# CITY OF ALBUQUERQUE

RE: **1<sup>st</sup> Nations Community Healthsource Bldg C Addition**  
**5608 Zuni SE**  
**Grading and Drainage Plan**  
**Engineers Stamp Date: 3/5/19**  
**Drainage File: L18D047A**

Based on the submittal received on 3/6/19, the Grading and Drainage Plan is approved for Paving, Building, and SO-19 Permits for the Bldg C Addition.

C-002

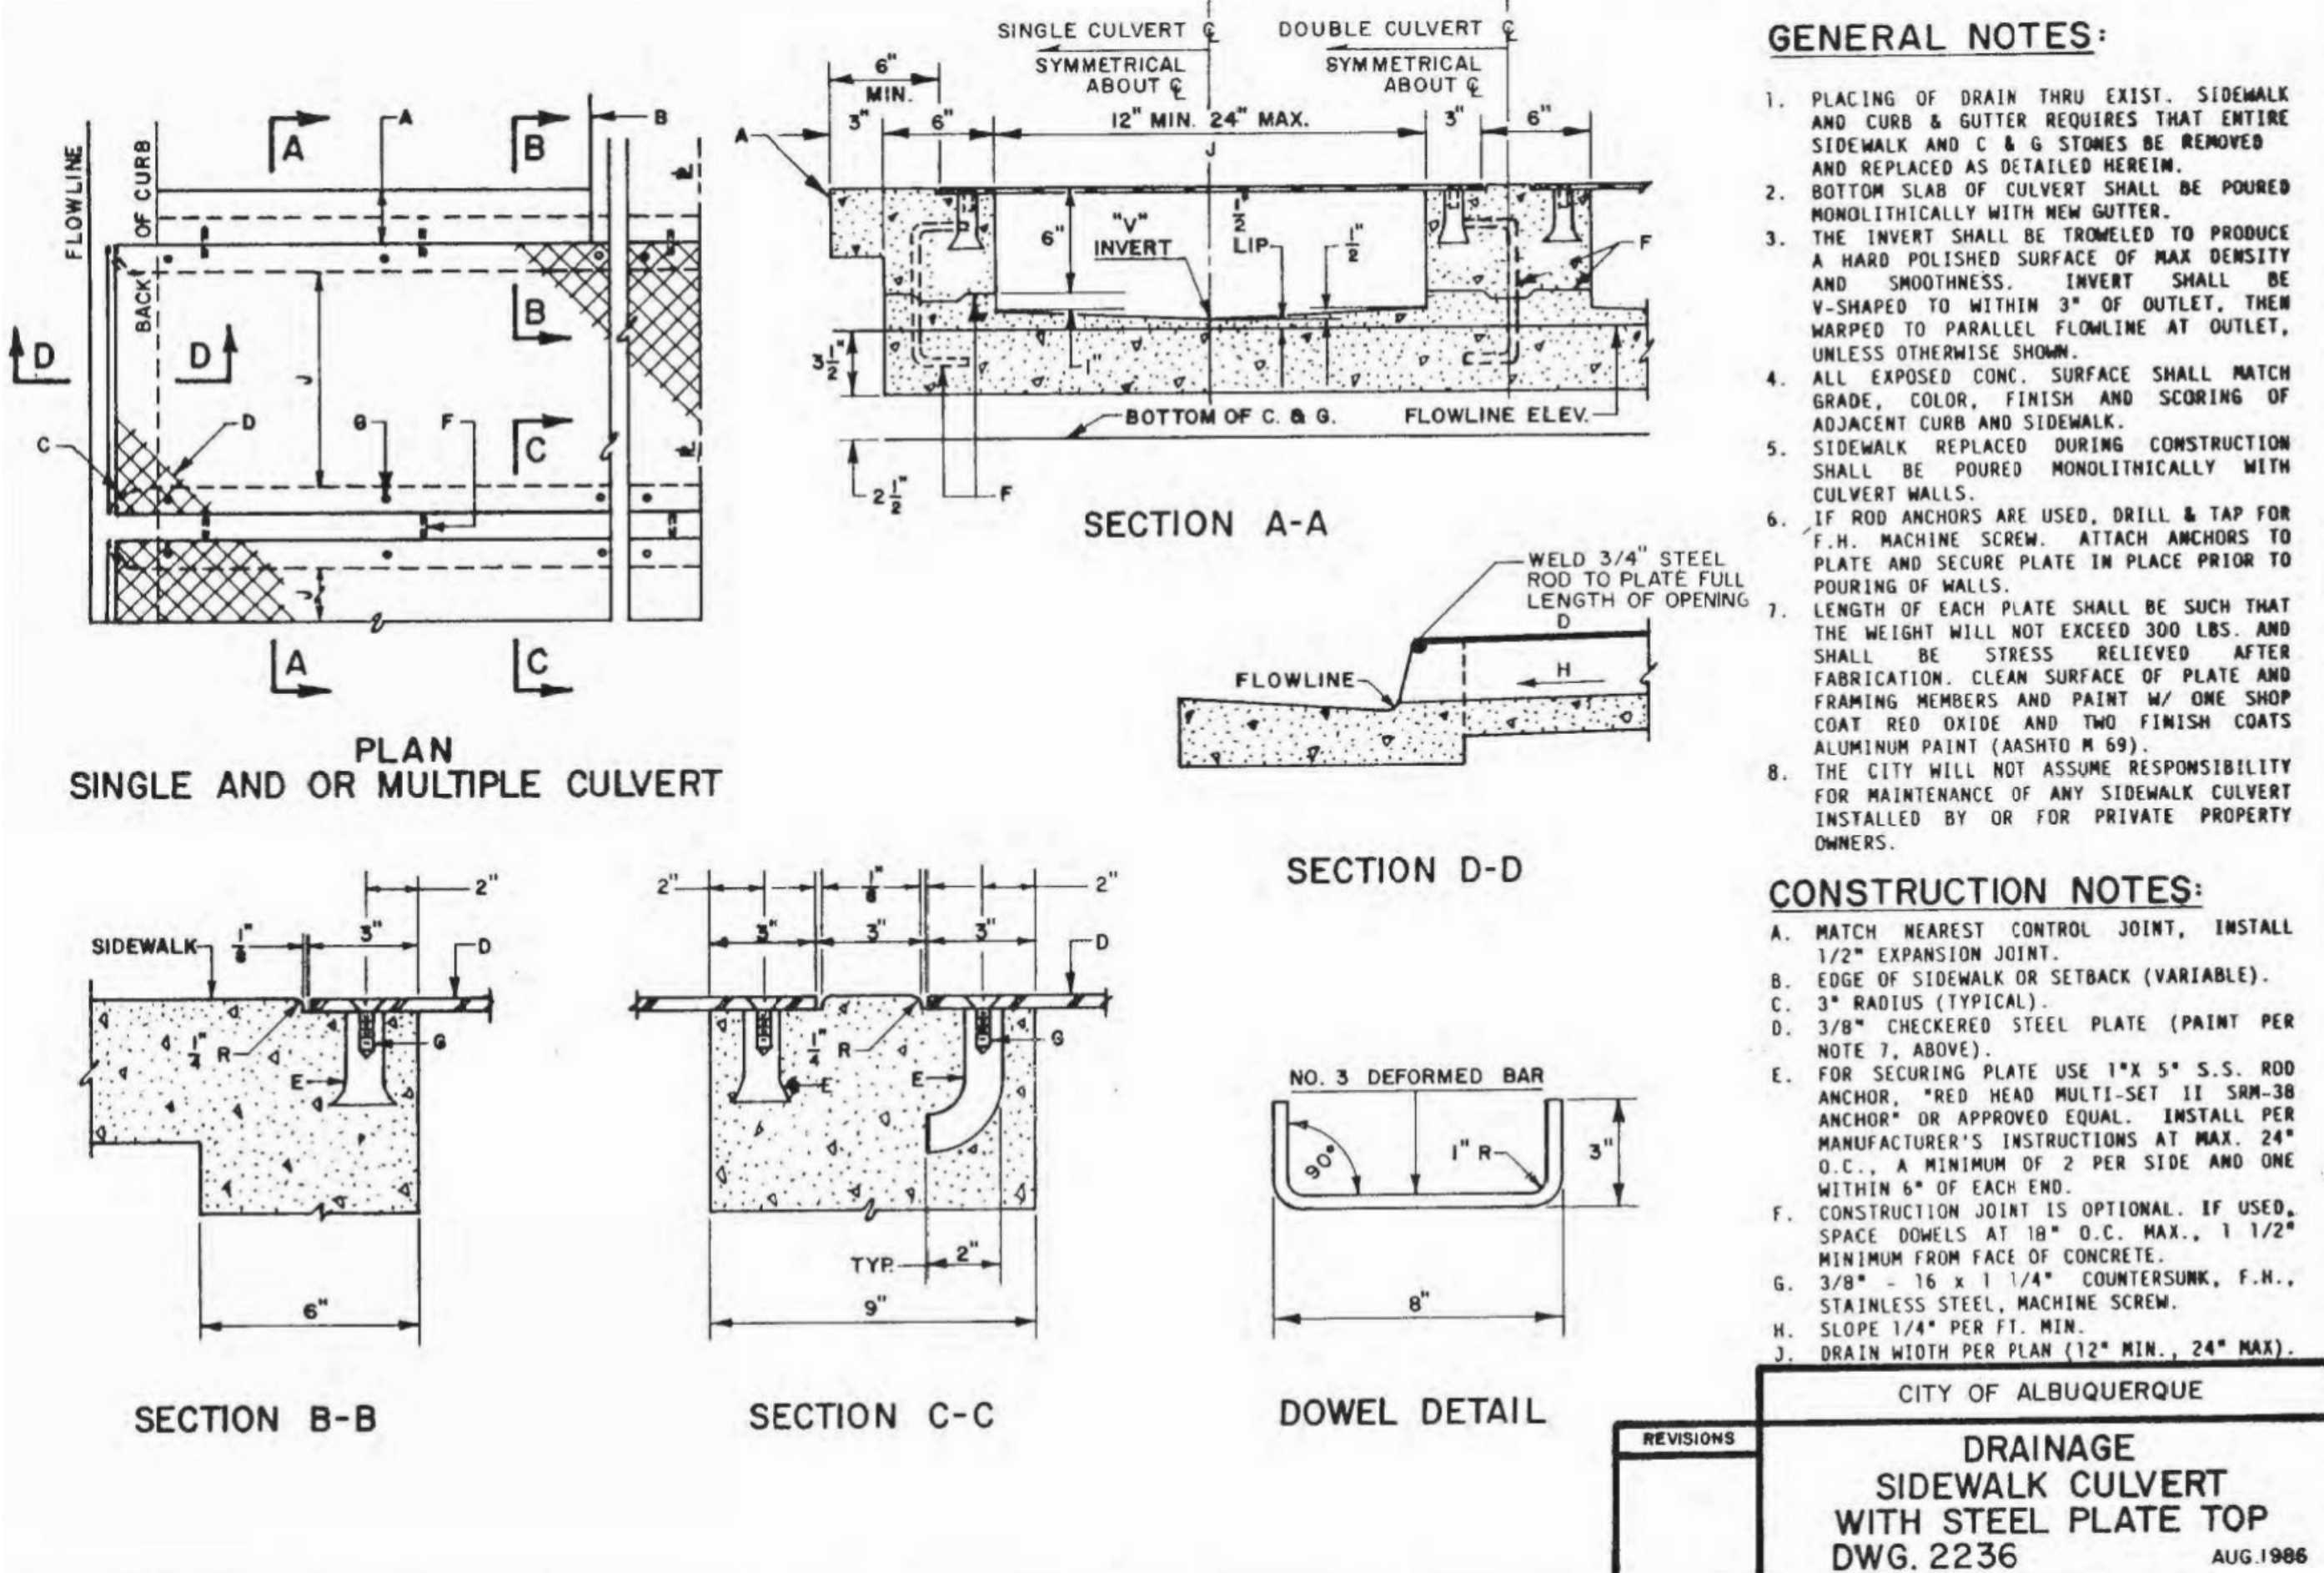
1. Engineer's Certification, per the DPM Chapter 22.7: *Engineer's Certification Checklist For Non-Subdivision* is required.
2. The sidewalk culverts must be inspected and approved by storm drain maintenance (David Harrison, dsharrison@cabq.gov or 857-8053).
